Entergy Nuclear Operations, Inc.  
Vermont Yankee  
320 Governor Hunt Rd  
Vernon, VT 05354  
Tel 802 257 7711

BVY 13-097

SUBJECT: Technical Specifications Proposed Change No. 306  
Eliminate Certain ESF Requirements during Movement of Irradiated Fuel  
Vermont Yankee Nuclear Power Station  
Docket No. 50-271  
License No. DPR-28

Proposed Change 306

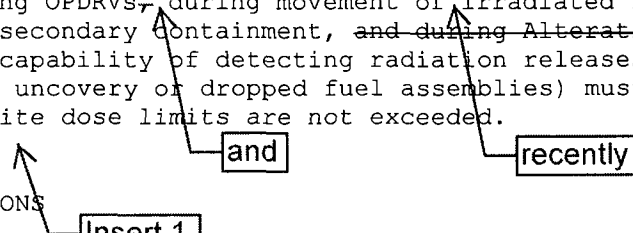
The High Reactor Building Ventilation Radiation and High Refueling Floor Zone Radiation Trip Functions are required to be operable in RUN, STARTUP/HOT STANDBY, HOT SHUTDOWN, Refuel (with reactor coolant temperature  $> 212^{\circ}\text{F}$ ) where considerable energy exists in the RCS; thus, there is a possibility of pipe breaks resulting in significant releases of radioactive steam and gas. In COLD SHUTDOWN and Refuel (with reactor coolant temperature  $\leq 212^{\circ}\text{F}$ ), the probability and consequences of these events are low due to the RCS pressure and temperature limitations of these Modes; thus, these Trip Functions are not required. In addition, the Trip Functions are also required to be operable during OPDRVs, during movement of irradiated fuel assemblies ~~or fuel cask~~ in the secondary containment, ~~and during Alteration of the Reactor Core~~, because the capability of detecting radiation releases due to fuel failures (due to fuel uncover or dropped fuel assemblies) must be provided to ensure that offsite dose limits are not exceeded.

ACTIONS  and recently
